[Docket No. 2000–SW–33–AD; Amendment 39–11881; AD 2000–17–07]

#### **Airworthiness Directives; Eurocopter France Model EC120B Helicopters**

**ACTION:** Final rule; request for comments.

Figure 1

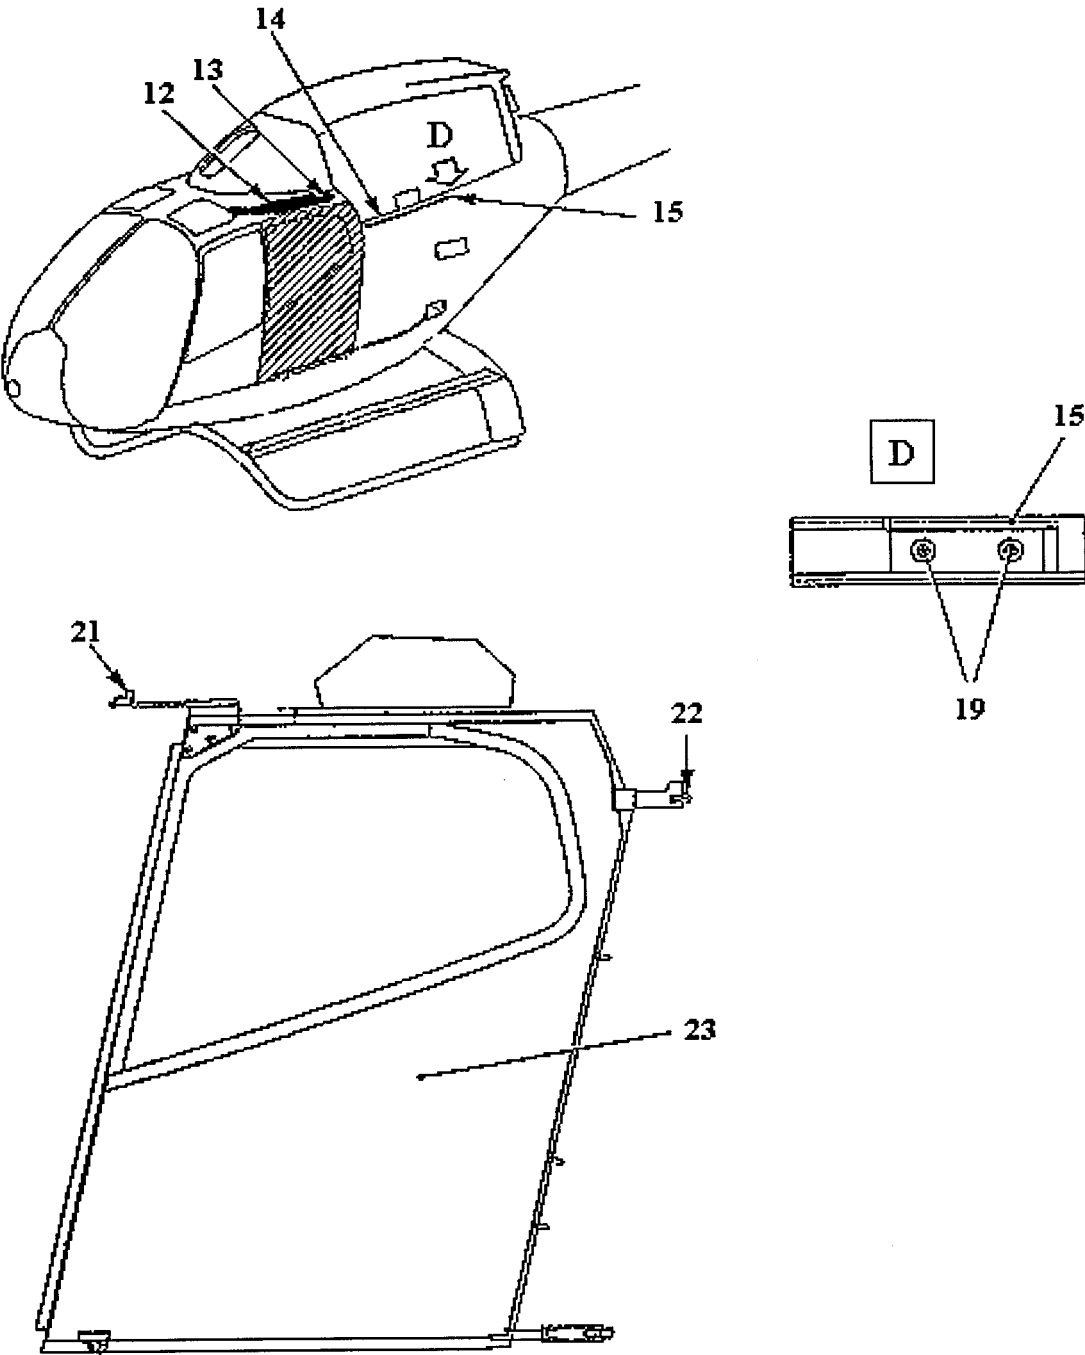
(a) Adjust the cabin sliding door (23) (see Figure 1) in accordance with the following:

(1) Loosen the screws (19) and the stop (15).

(2) Open and push the cabin sliding door aft until the roller goes past the locking pin (13) while keeping the roller (21) inside the rail (12).

(3) Move the cabin sliding door forward to bring the roller (21) into contact with the locking pin (13).

(4) Move the stop (15) as far forward as possible toward the nose of the aircraft.

(5) Mark the location of the stop (15) with respect to the rail (14).

(6) Unlock the cabin sliding door and move it forward to gain access to the screws (19).

(7) Hold the stop (15) aligned with the rail (14), and secure the stop (15) and the screws (19) at the location previously marked.

(8) Ensure that the pin (13) locking mechanism (pin) locks the cabin sliding door in the open position. If the pin does not lock the door in the open position, before further flight, repair or replace the pin with an airworthy pin.

(9) Bring the roller (22) into contact with the stop (15) of the rail (14).

(10) If the roller (21) is completely inside the rail (12) with a minimum clearance of 3 mm from the aft end of the rail (12), the cabin door is properly adjusted and no further action is required by this AD.

(11) If the roller (21) is less than 3 mm from the aft end of the rail (12), before further flight, repeat steps (1) through (10) until a minimum clearance of 3 mm is obtained.
